Lahore Water and Wastewater Management
Project (LWWMP)

3rd Set of Clarifications

**LAHORE WASTEWATER AND DRAINAGE MANAGEMENT
PROJECT (LWDMP) - SEWERAGE SYSTEM FROM LARECHS
COLONY TO GULSHAN E RAVI, LAHORE (THROUGH
TRENCHLESS TECHNOLOGY)**

LAHORE WATER AND WASTEWATER MANAGEMENT PROJECT (LWWMP)
SEWERAGE SYSTEM FROM LARECH COLONY TO GULSHAN-E-RAVI LAHORE
Third Set of Clarification on Tenderer's Queries

DRAWING NO.:-
LW-TD-151

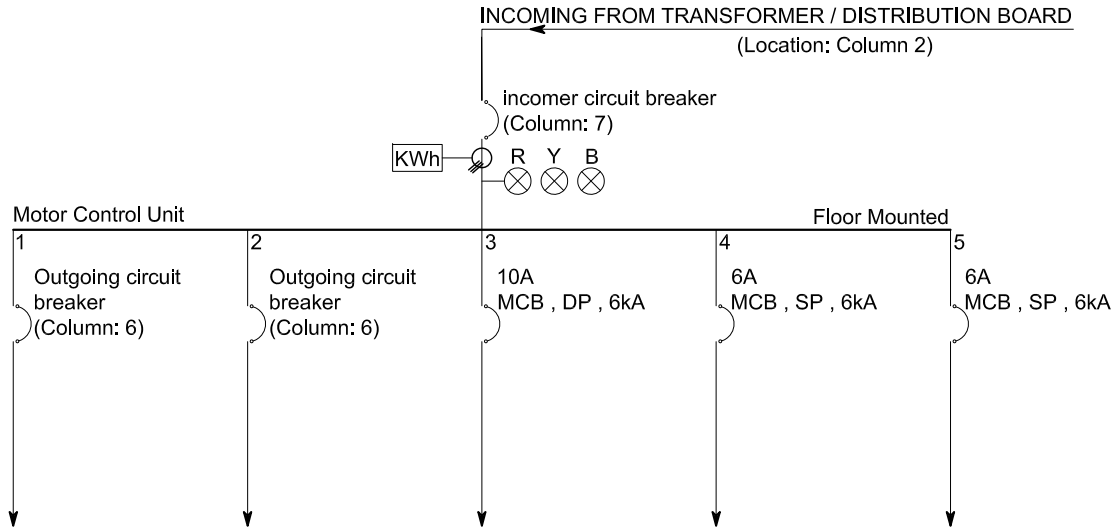
Sr #	Reference Section	Description	Employer's Response
1.	Volume 1, Part I, Section 4, Tender Forms Page 4-46-4-62 Schedule No. 5: Electrical Works	Electrical works in 23 Intermittent Pumping Stations Electrical works along sewer lines (15 Nos. Control System at Drop Structures) & 15 Nos. Control Points on Manholes along Lines and Laterals preferably at drop structures in accordance with ER Sub Clause 4.1 & 5.1 5 Nos. (minimum) Control Points on Manholes along Lines and Laterals ULTIMATE DISPOSAL STATION AT GULSHAN E RAVI (ELECTRICAL WORKS FOR PUMPING STATION AND ALL BUILDINGS REFERRED IN EMPLOYER'S REQUIREMENTS The Tenderer notes that only the Single Line Diagram (SLD) for the Disposal Station has been provided. The Tenderer respectfully requests the Employer to provide the load list, SLDs, layout drawings, and any additional electrical drawings for other stations, if available.	It is to clarify that EPC Contractor is responsible for detailed design of loads and SLDs for all the stations, however, the load requirement for all 23 intermittent pumping stations and typical SLDs for odor control system, ventilation system and screening system is attached as Annex-A for guidance only.

ULTIMATE DISPOSAL STATION MASTER LAYOUT PLAN PUMP HOUSE		
DATE:-	NOVEMBER, 2025	DRAWING NO.:-
		LW - TD - 402

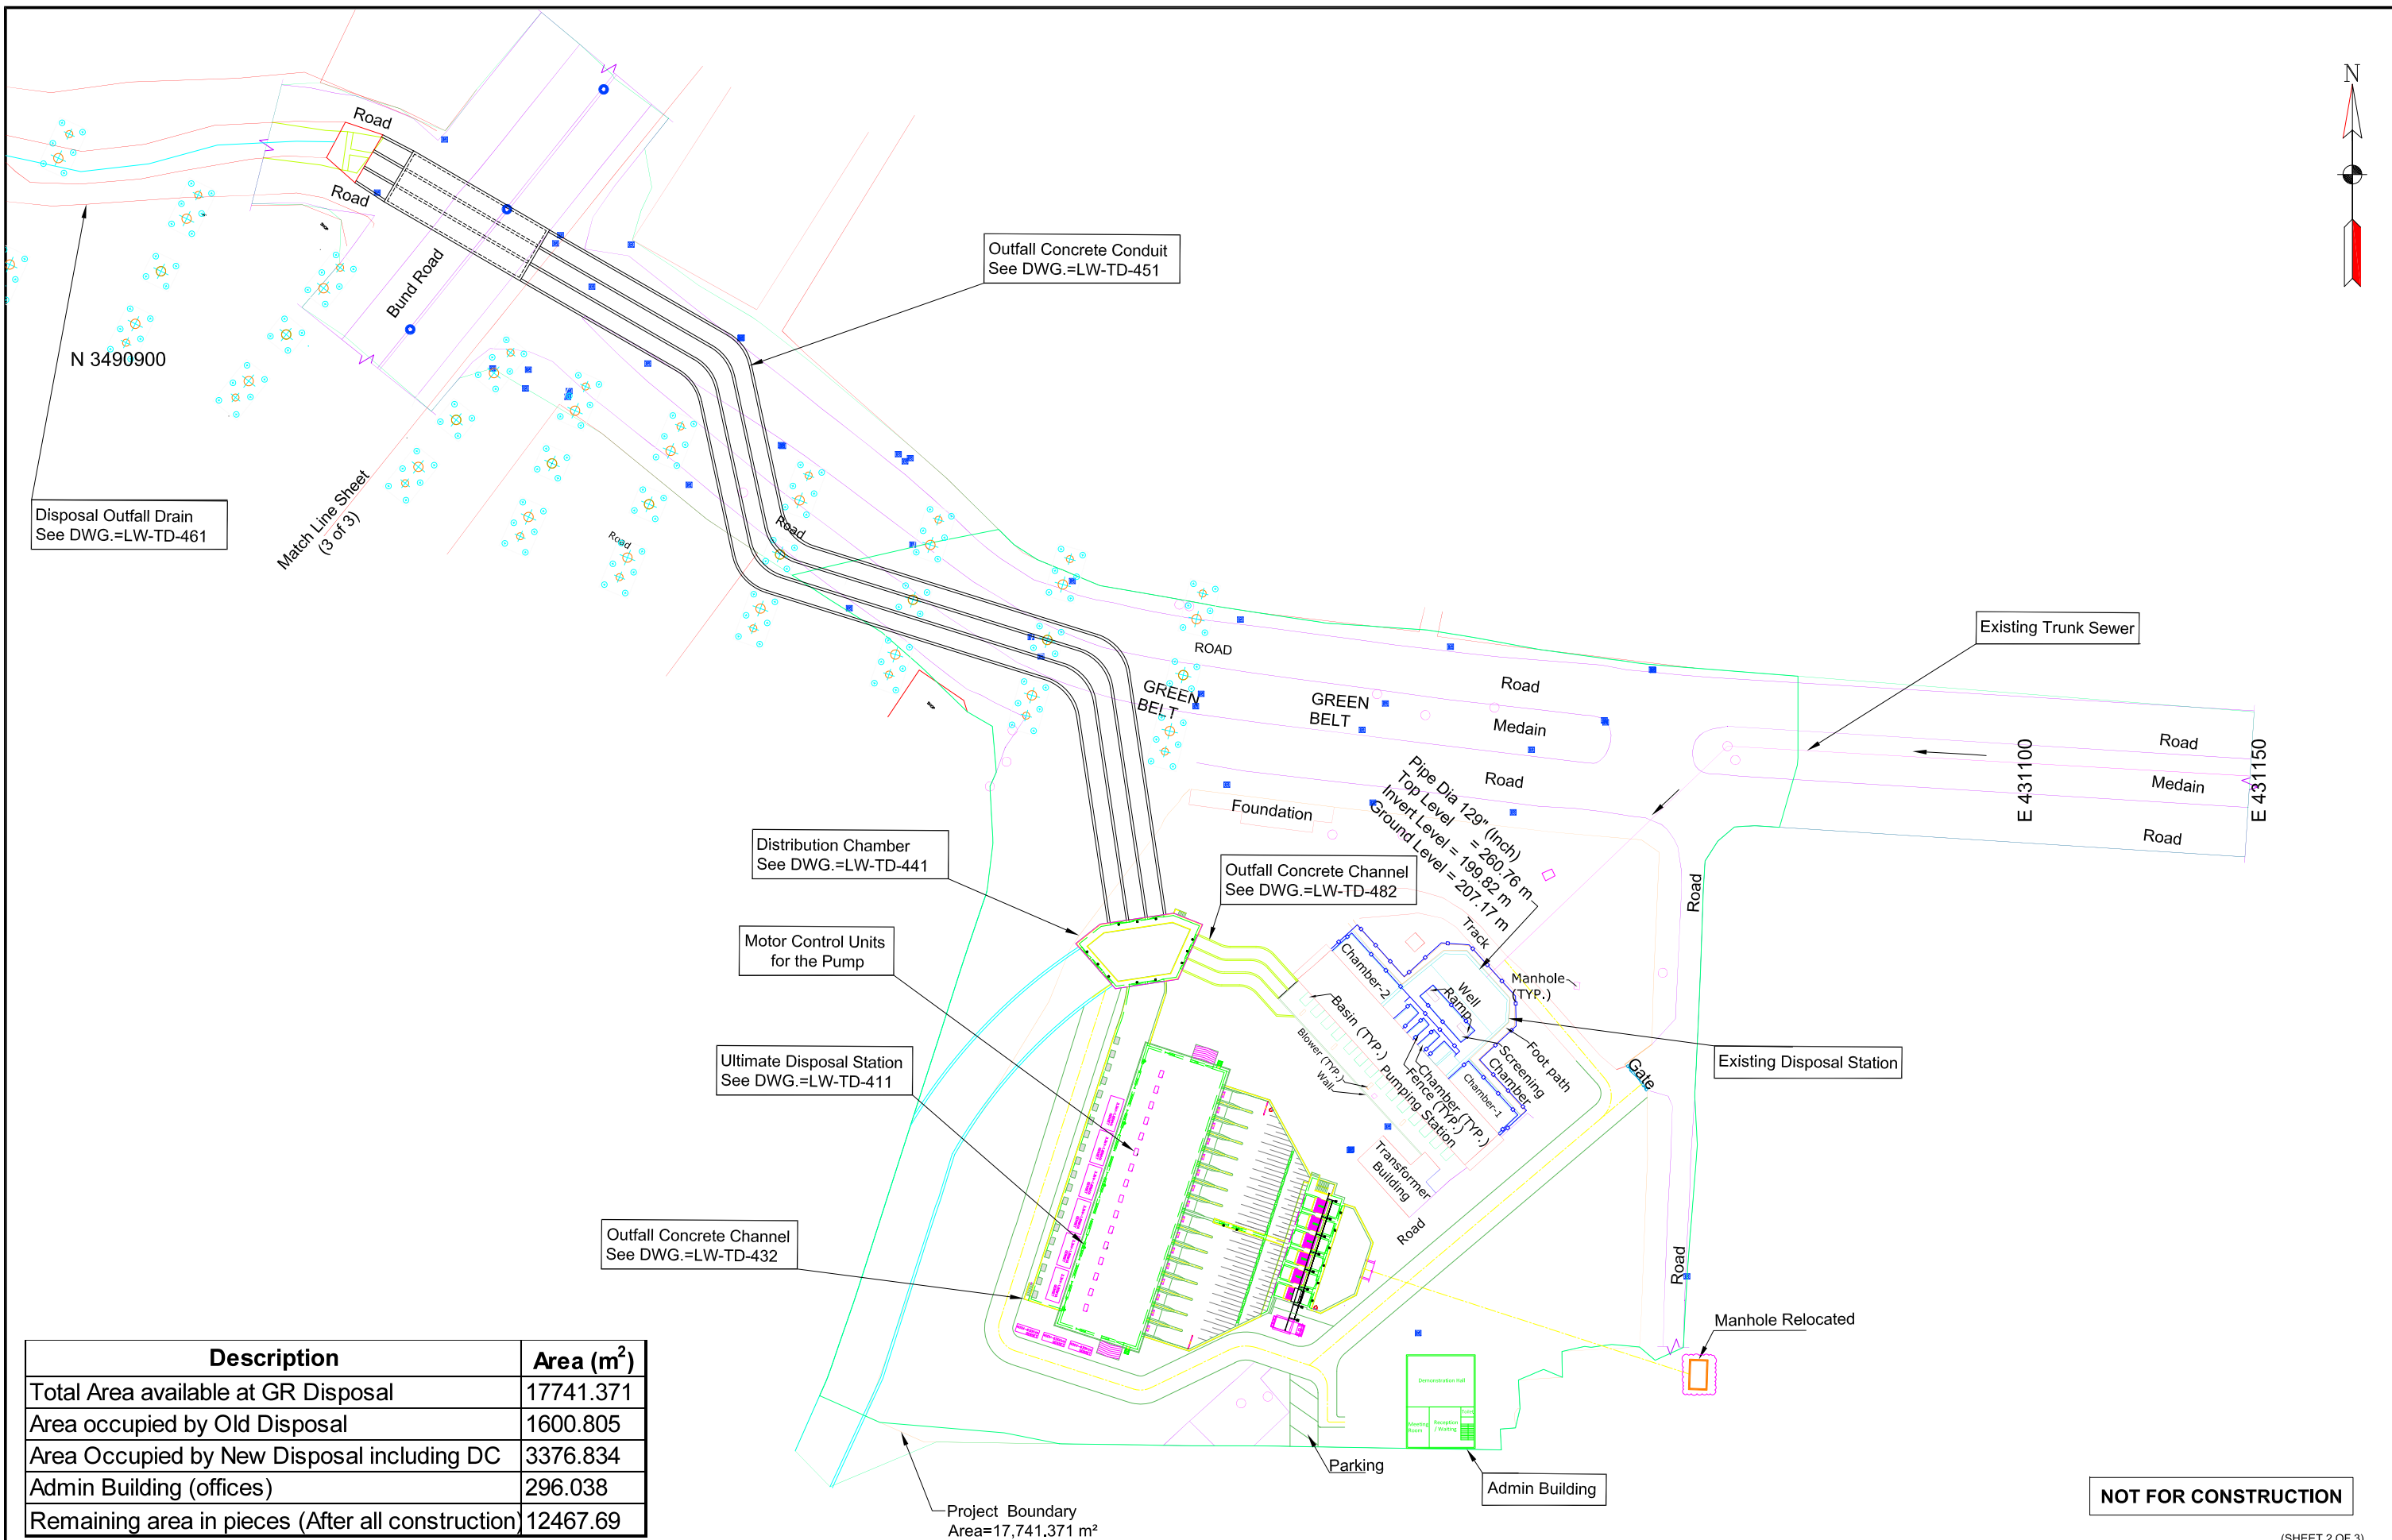
2.	Volume 2 Part II, Section 6, Employer's Requirements	It is recommended that the panel rooms can be adjusted in the dry well chamber. Can this alternate arrangement be acceptable to the Employer.	Kindly refer to response at Sr. No. 39 of the Clarifications and Minutes of Meeting of 1st Pre-Tender Meeting , wherein, the updated drawing # LW-TD-411 shall prevail, however, as an alternative arrangement, the panel rooms can be adjusted in the dry well chamber as per Annex-B .

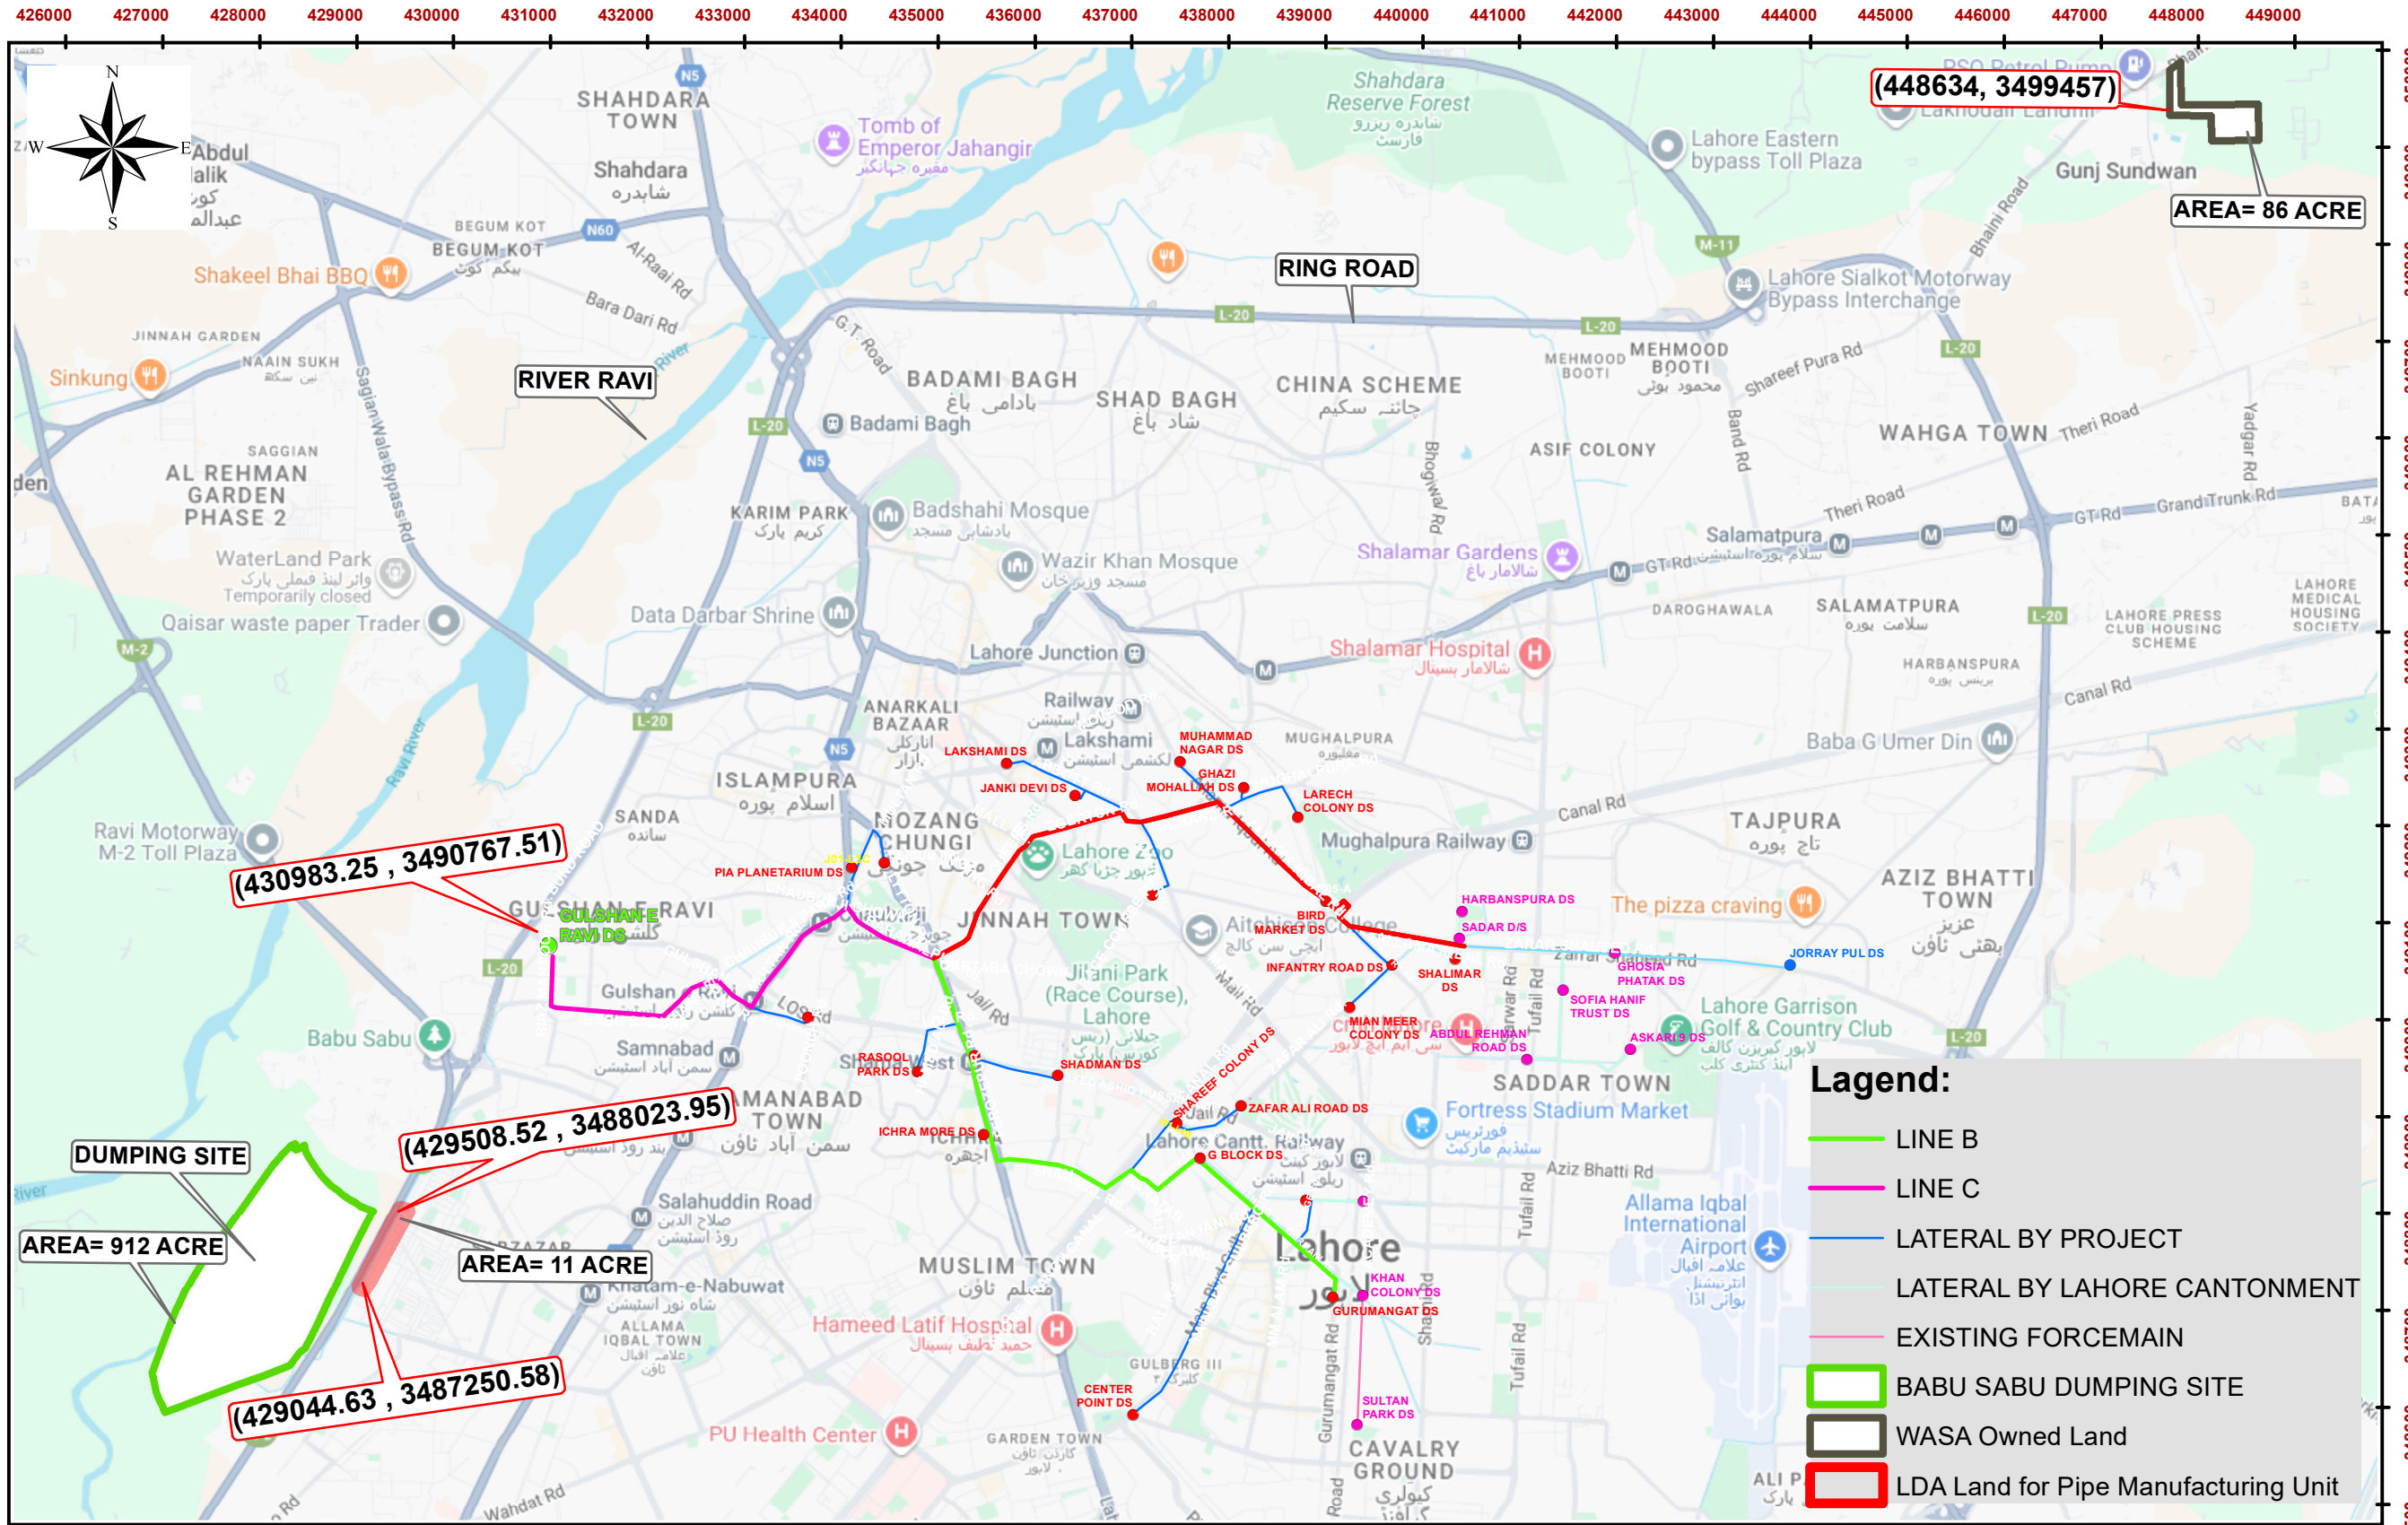
17.	Volume 2, Part II, Section 6, Employer's Requirement	During the site visit, the Tenderer has identified an additional parcel of land probably owned by Lahore Development Authority (LDA), located in proximity to the Project area and WASA owned land, which appears suitable for use as a pipe manufacturing and casting yard. In this regard, the Tenderer seeks clarification	It is to clarify that in addition to the sites identified in the Tender Documents, the Contractor may utilize any other suitable land, including the land owned by Lahore Development Authority (LDA) identified during the site visit, for pipe manufacturing and associated activities, subject to obtaining all requisite approvals and NOCs from the relevant authorities. In this regard, the updated

Sr #	Reference Section	Description	Employer's Response
		whether, subject to obtaining all requisite approvals and permissions from the relevant authorities, the said land may also be utilized for pipe manufacturing, storage, and associated construction activities under the Contract.	drawing for sites that can be used by the Contractor are attached as Annex-D .
